Rev	Date	Drawn	Description
A	05.04.23	ALA	Initial Issue For Planning
B	05.05.23	TBO	Issue For Planning
C	03.11.23	DEG	Planning Amendments (see notes)
D	21.11.23	DEG	Drainage, Site Levels & FFL Coordination
E	13.06.26	KDU	Non-material Amendment (see notes)

Proposed Elevations	HTA-A_DR_0250	E
drawing title: Block A	drawing number	revision
Reading Borough Council		
Dwyer Road		
client / project		
1:100	RBC-DRR	DEG
scale @ A1	project number	originated by
HTA Design LLP		
www.hta.co.uk		
London Edinburgh Manchester Bristol		
FOR PLANNING		
status

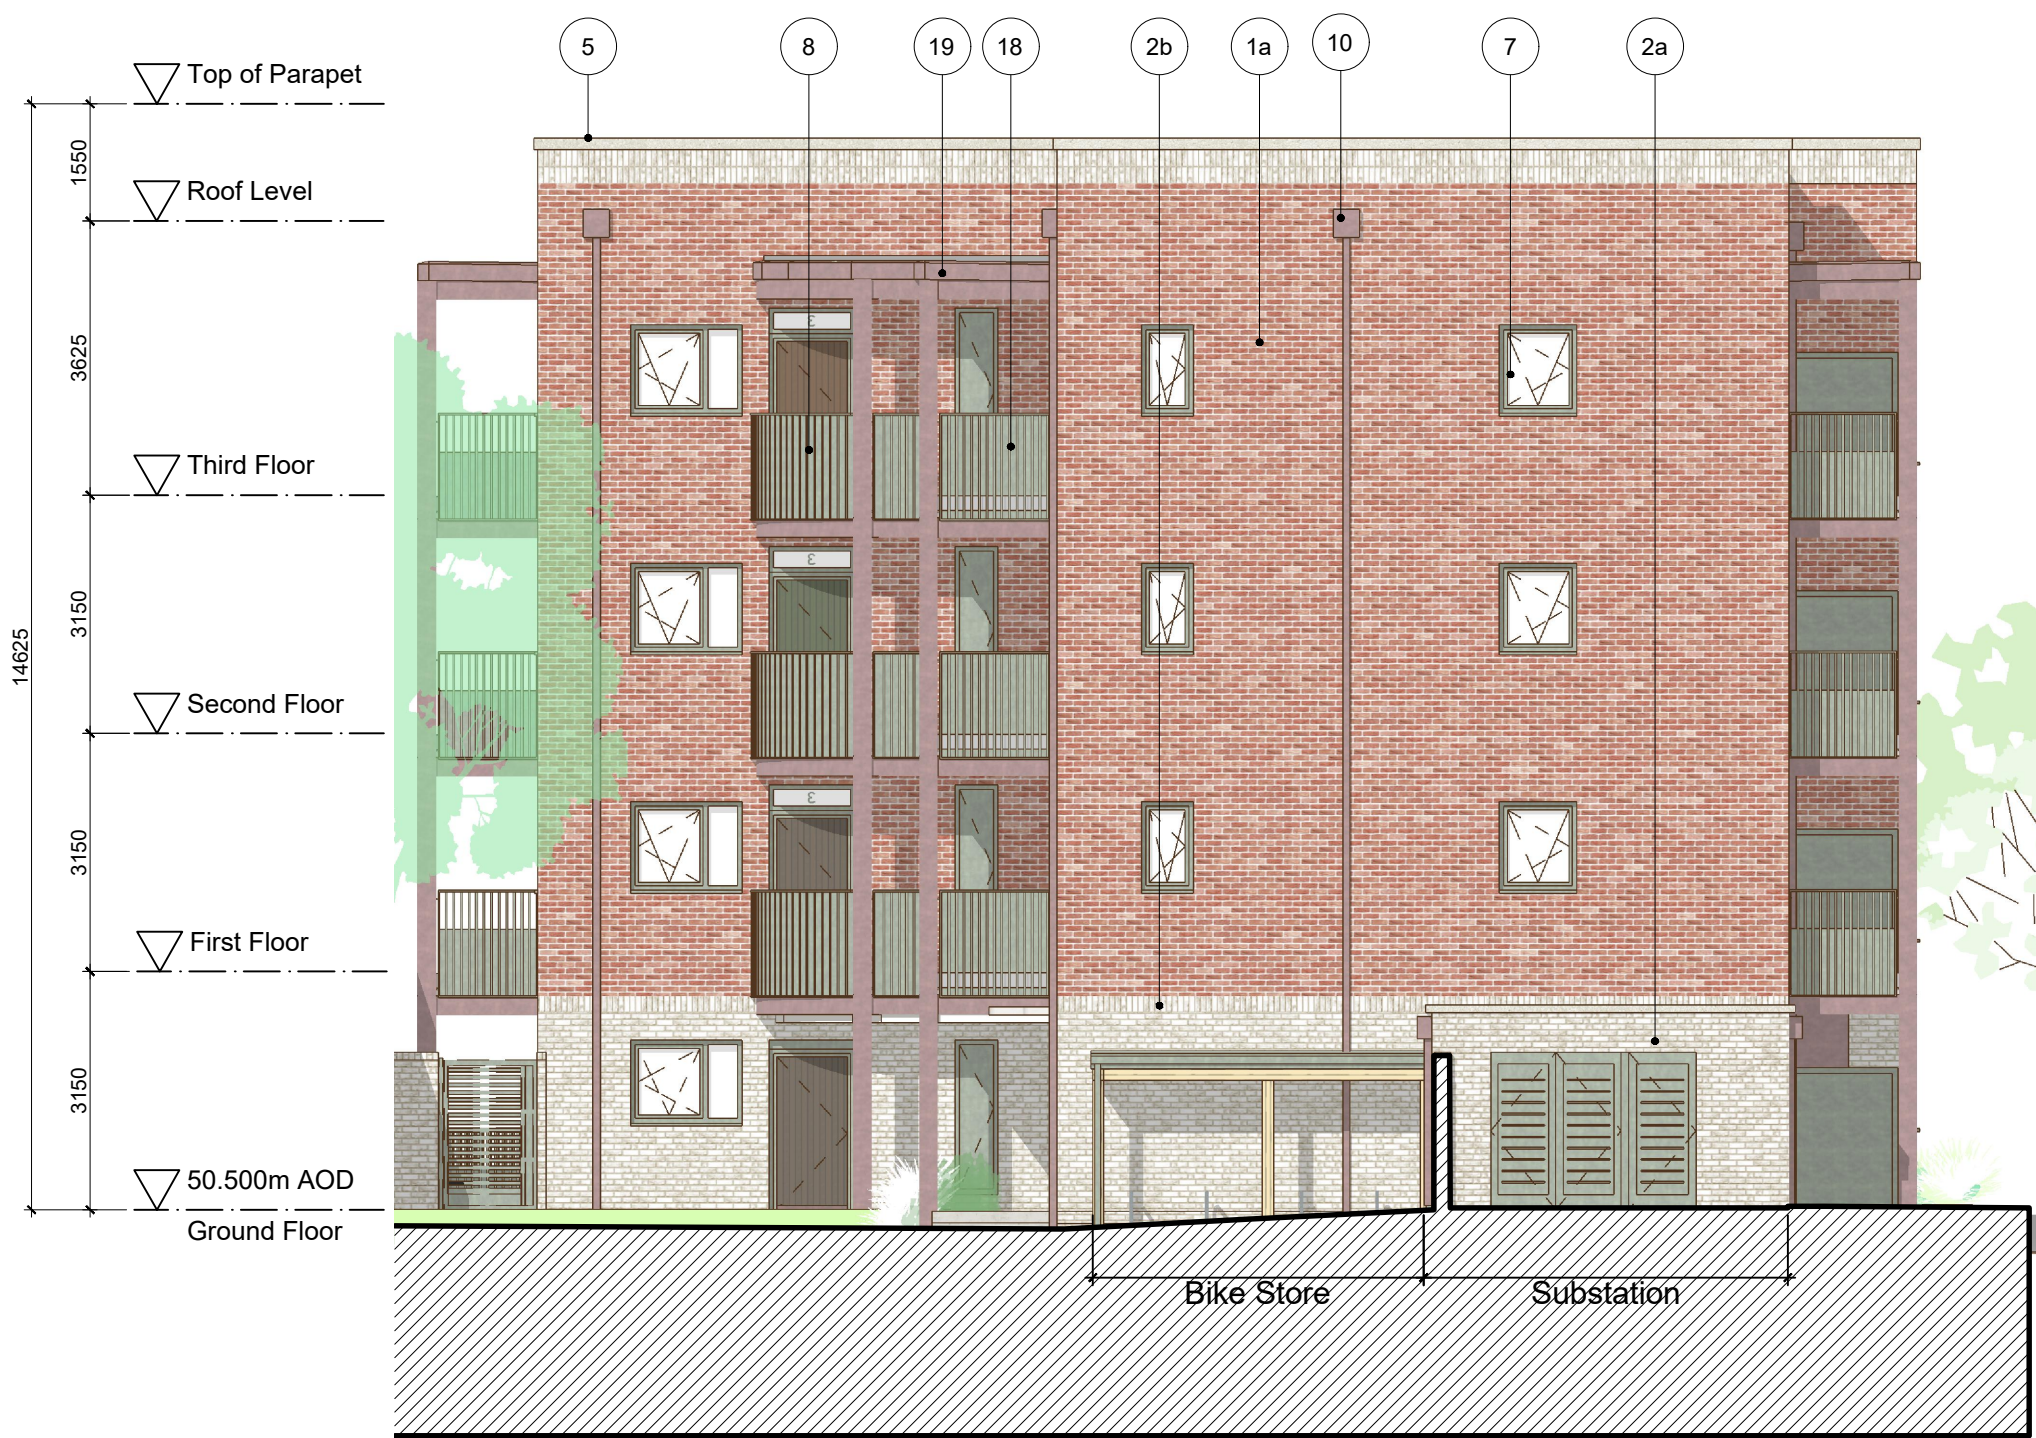
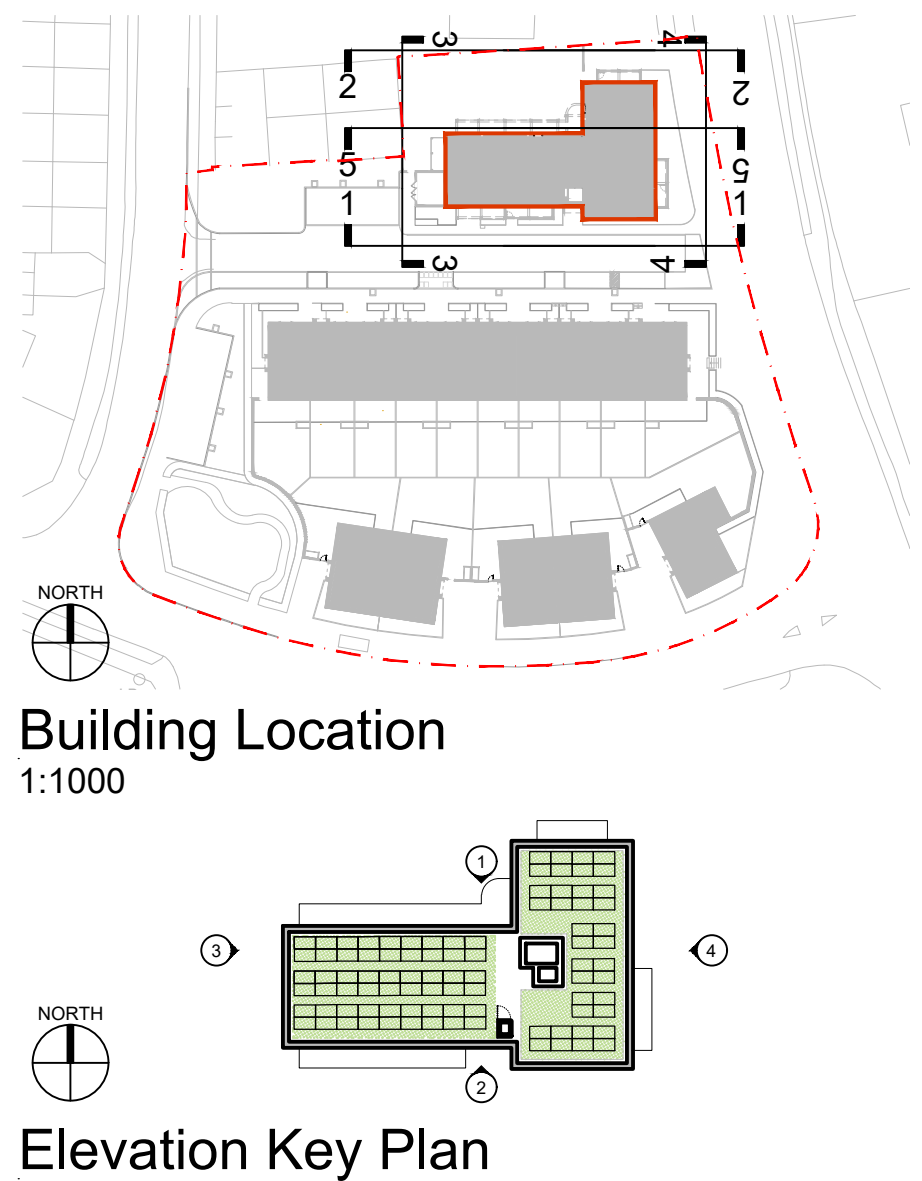
Design Amendments in response to RBC Planning officer comments
1) Solar shades removed (not required for overheating strategy)
2) Site setting out updated to reflect design development (wall thickness and brick dimension coordination)

3) Flat block ground floor deck - introduction of PPC metal soffit downstand to conceal building services
4) Dry Riser inlet and outlet position amended to accord with revised fire access strategy
NMA Design Amendments

1) Deck and balcony structural frame changed from pre-cast concrete to painted steel
2) Communal window revised to remove Juliette balcony, to include opening lights with fixed lower panes

3) Communal entrance component revised to reduce width of door set and omit fixed metal panel in favour of brickwork
4) Communal entrance canopy revised to omit pre-cast concrete and match proposed painted steel elsewhere

5) Minor amendments to window and door setting out, to reflect plan refinements.
6) Minor amendments to rainwater pipe hopper locations at roof level
